AMENDMENTS TO THE DRAWINGS

REMARKS/ARGUMENTS

Fig 1a

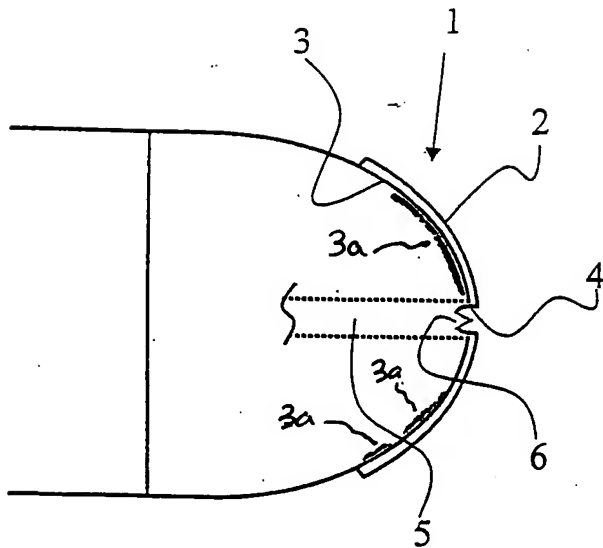
The attached sheets of drawings add glue 3a (and associated reference characters and lead lines) in Figure 1a.

The attached sheets of drawings add glue 3a (and associated reference characters and lead lines) in Figure 1a. Additionally, Applicant submits that Figure 1a shows inner side 3 formed as a substantially flat or weakly bending disk.

Fig 2

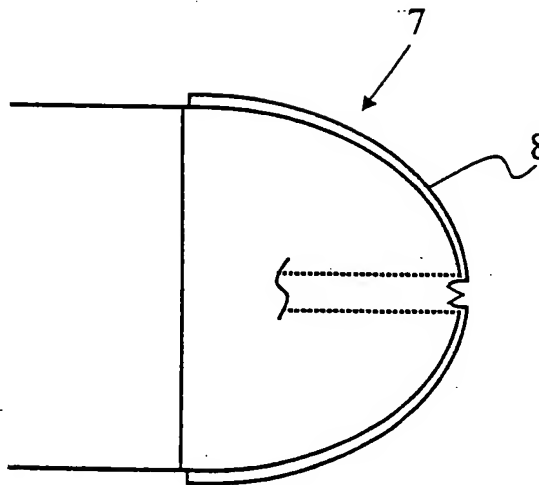
Applicant amends the specification to recite "[f]igure 2 shows in diagrammatic representation a device for preventing transmission of bodily fluids during sexual relations according to a second embodiment of the invention" and "[s]ince the second part 4 extends at least a little into the urethra 5, the outer parts of the urethra 5 and the top of the glans are also protected after the membrane 6 has burst."
